# Responses to Reviewer 1

## General Comments:

Variables of interest for a content of  $2 \cdot 10^{-5}$  kg/m<sup>3</sup> at Ka band:

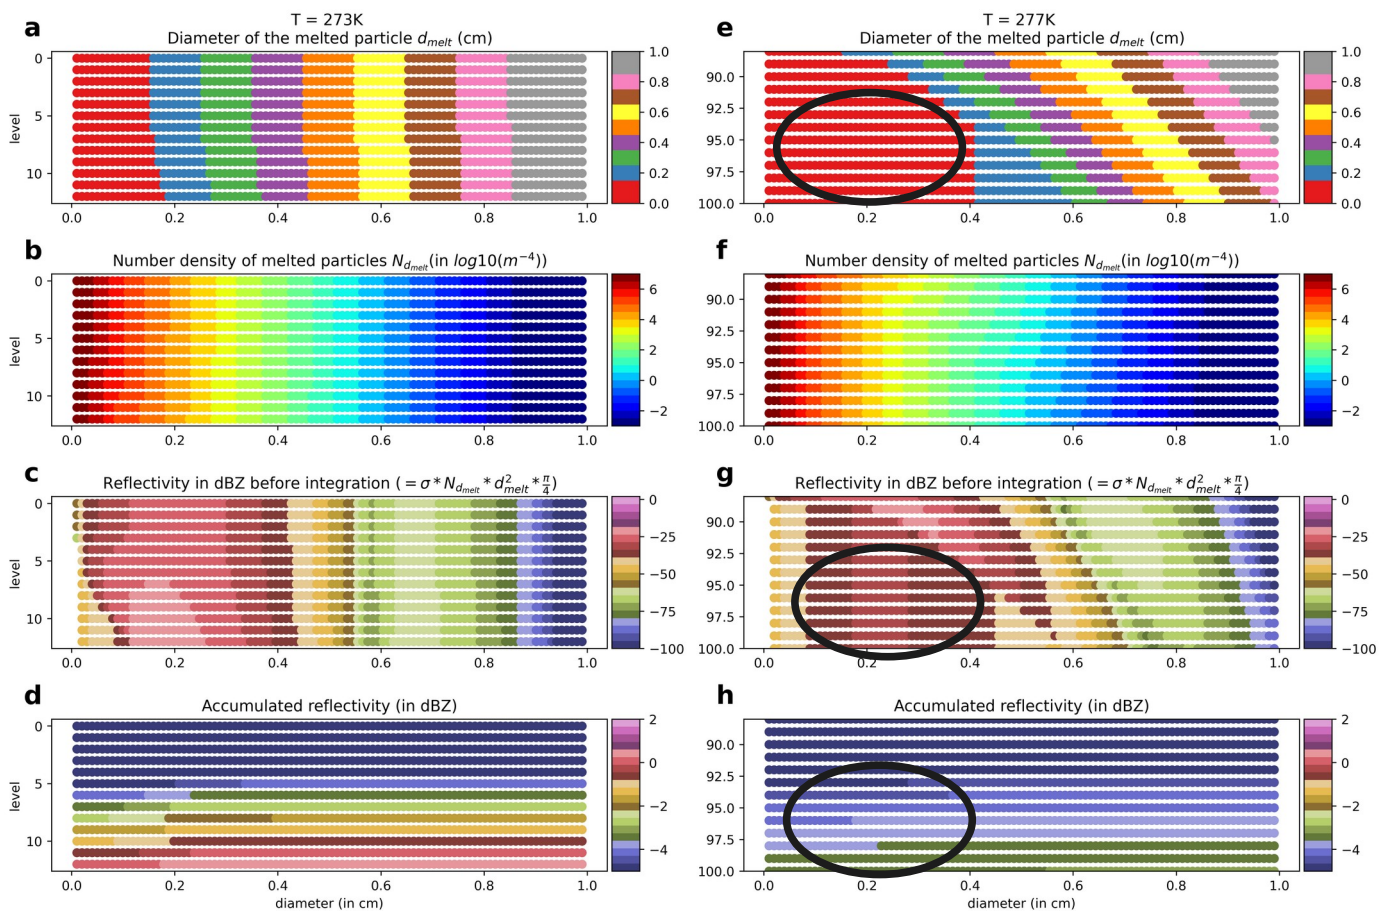
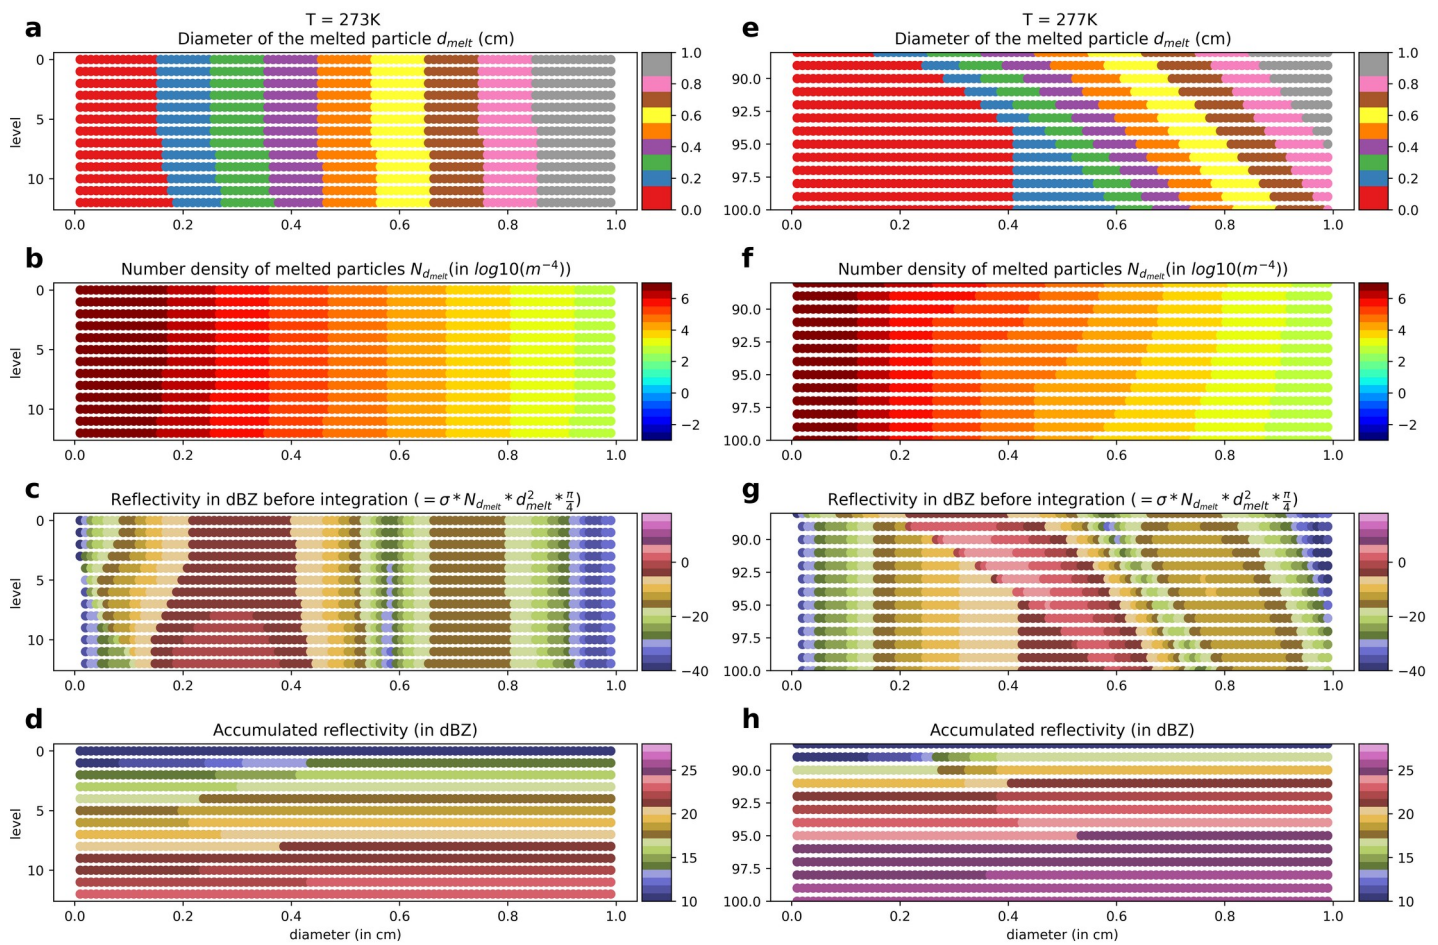
**Comment 15: p.12/13 figure 3/4: Why do the lines at different temperatures cross without following any rules.**

**Response 15:** The authors would like to thank the reviewer for this interesting question. To answer this particular point, the authors investigated why the reflectivity is larger (resp. smaller) at 273K than at 277K for a content of  $2 \cdot 10^{-5}$  kg/m<sup>3</sup> (resp. 10<sup>-3</sup> kg/m<sup>3</sup>). This non-linear behaviour is due to the evolution of the melting process, which is different at 273K than at 277K.

Indeed, in the next two figures, the authors show the variables which play a key role in the computation of the reflectivity inside the melting layer, for the two different temperature bins. The

variables are shown as a function of the level inside each sub-melting layer on the y axis, and as a function of the diameter (x axis). The colorbar represents one variable of interest. The results are shown at Ka band only. They are shown on the left columns for the 273K bin, and on the right columns for the 277K bin. The authors have plotted:

- **The diameter of the melted particle (top panels a and e):** This diameter can be seen as the remaining frozen part of a given melted particle. It is equal to the frozen diameter at the top of the sub-melting layer, and it is equal to 0 (red colours) when the particle is fully melted. A given vertical column of the two-dimensional plot represents the melting process for a particular particle of diameter  $D$  across the sub-melting layer. For the 273K bin (top left panel, a), the melting process is slower than for the 277K bin (top right panel, e) because of the colder temperature. Therefore, the melted diameters are always almost equal to the frozen diameter for the 273K bin, except for the smallest diameters at the end of the 273K sub-melting layer. However, the melting process is quicker at 277K (see e panel) as more particles have their melted diameters which reach values close to 0 (red values).

- **The number density of the melted particles in panels b and f.**
- **The reflectivity before integrating over the PSD and the height levels** (it is displayed in dBZ in panels c and g): This value corresponds to the backscattering cross-section, multiplied by the melted number density (for the melted diameter  $d_{\text{melt}}$ ), and by the square value of the melted diameter (the equation is given in the subtitle). Therefore, when a particle is melted (i.e. its melted diameter equals 0), then its associated backscattering cross-section (for a given diameter and a given level) is close to 0 because the backscattering cross-section is multiplied by the diameter of the remaining frozen part of the particle. Therefore, wherever (in terms of levels and diameters) a particle is melted, its contribution to the overall reflectivity is very small (see for instance the area displayed by the black circle).

- **The reflectivity after integrating over the PSD and the height levels (panels d and h):** in the 2D plot, one can see the reflectivity that is being accumulated over the PSD and the height levels across the 273K bin (d) and the 277 K bin (h). The value on the bottom right corresponds to the value which is stored in the look-up table for this specific bin. For a content of  $2 \cdot 10^{-5} \text{ kg/m}^3$ , the final value (about 0~dBZ) is larger for the 273K bin, compared to the value of the 277K bin (about -3dB). This is because the areas in which the particles are completely melted at 277K, corresponds to levels in which they are not melted at all at 273K. Therefore, their contributions to the overall reflectivity is larger at 273K than at 277K, especially as there is a very large number of small particles for this content. This behaviour is not observed for larger content because of the PSD (see for instance the comparisons of the number density plots between a content of  $10^{-3} \text{ kg/m}^3$  and a content of  $2 \cdot 10^{-5} \text{ kg/m}^3$ ). Indeed, the number of larger (resp. smaller) particles is larger (resp. smaller) for larger contents, and these large particles are not fully melted in most of the levels of the different

sub-melting layers. Therefore, we end up with a more logical behaviour, with larger reflectivity at 277K than at 273K.

The authors added a sentence to briefly describe this behaviour in section 4.1. The authors recognise that the assumptions made on the evolution of the melting process within each sub-melting layer has a strong impact on the subsequent simulated reflectivities. To avoid this issue, an alternative could be to add the melted fraction (calculated based on the liquid and frozen contents of the NWP model) as a predictor in the lookup tables (in addition to the temperature and hydrometeor content), as it is done in the T-matrix ground-based (Augros et al. 2016) and airborne cloud (Borderies et al. 2018) radar forward operator. This requires a lot of work and is therefore left for future work.
